V2500 Propulsion System — Nacelle

Subject: Transmittal of Revision 4 to Service Bulletin Number
V2500-NAC-26-0009

**NACELLE - FIRE PROTECTION - HARNESS ASSEMBLY, OVERHEAT SENSOR -
REPLACEMENT OF**

V2500-NAC-26-0009
Page 1 of 9

OVERHEAT SENSOR HARNESS ASSEMBLY INSTALLATION.
FIGURE 1.

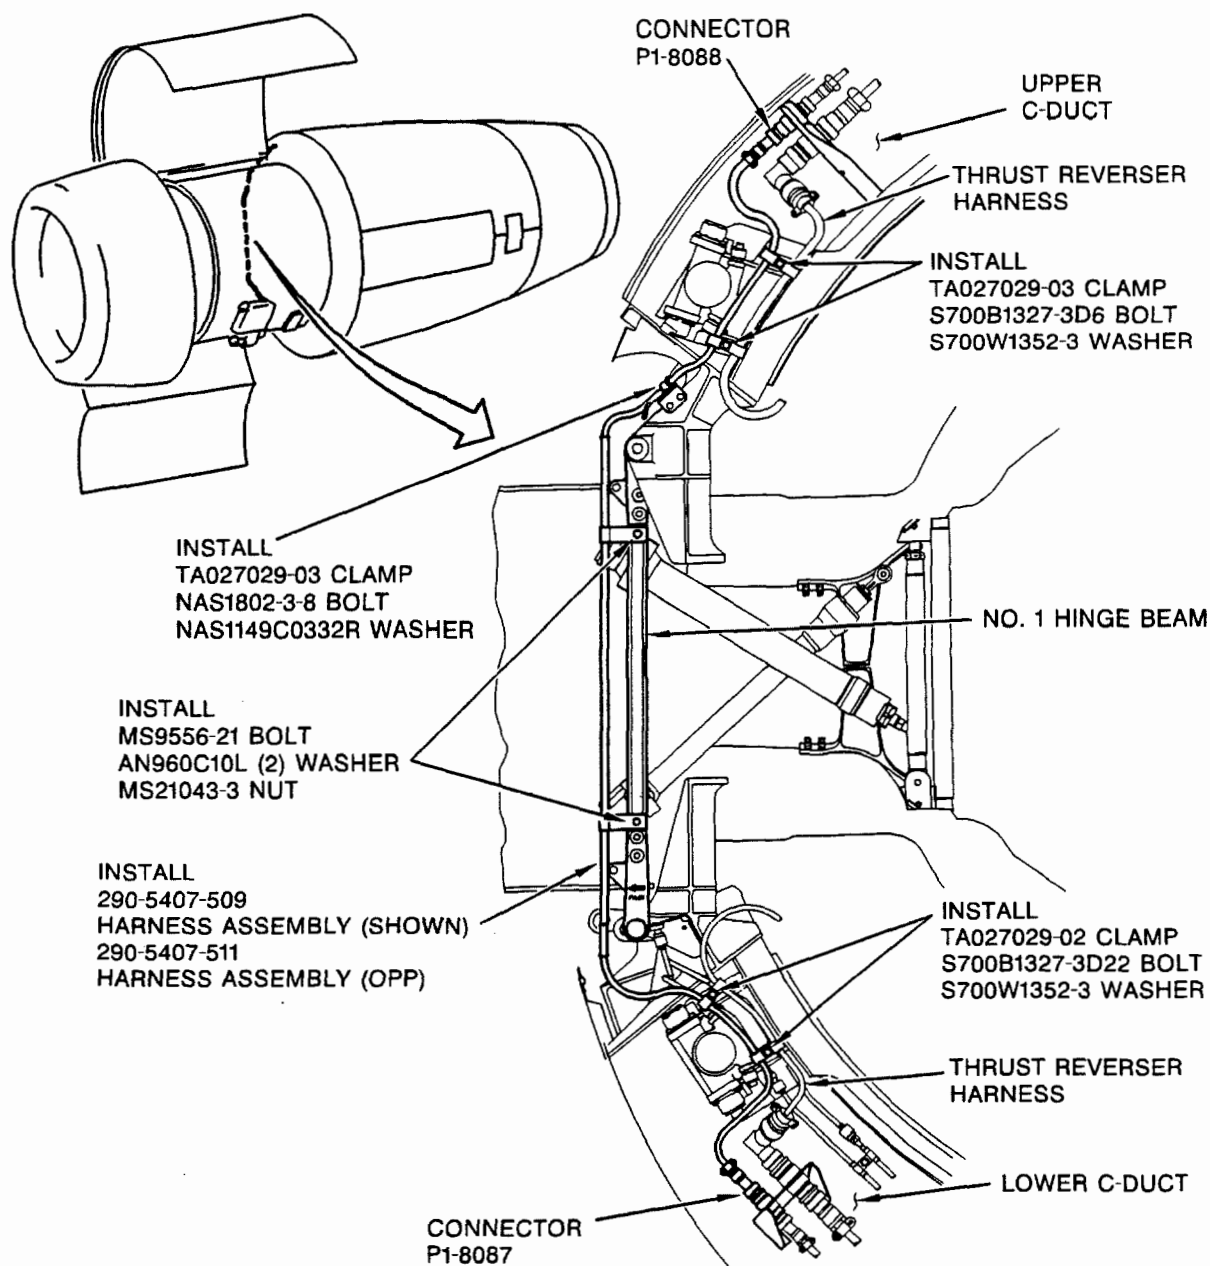
R The change introduced by this Bulletin is to replace the
R existing harness assemblies with new harness assemblies with
R improved clearance.

- R (1) Attach 290W5407-509 overheat sensor harness assembly to #1
hinge beam with two MS9556-21 bolts, four AN960C10L
washers, and two MS21043-3 nuts. Refer to Figure 1.

- (2) Attach overheat sensor harness assembly to upper C-duct
with TA027029-03 clamp, NAS1802-3-8 bolt, and
NAS1149C0332R washer.
- (3) Attach overheat sensor harness assembly and existing
thrust reverser harness to upper C-duct with two TA027029-
03 clamps, two S700B1327-3D6 bolts, and two S700W1352-3
washers.

- (4) Connect overheat sensor harness connector P1-8088 to upper
C-duct connector.
- (5) Attach overheat sensor harness assembly and existing
thrust reverser harness to lower C-duct with two TA027029-
02 clamps, two S700B1327-3D22 bolts, and two S700W1352-3
washers.

- (6) Connect overheat sensor harness connector P1-8087 to lower
C-duct connector.
- R (7) Repeat steps in paragraph (1) through (6) for 290W5407-511
right hand overheat sensor harness assembly.
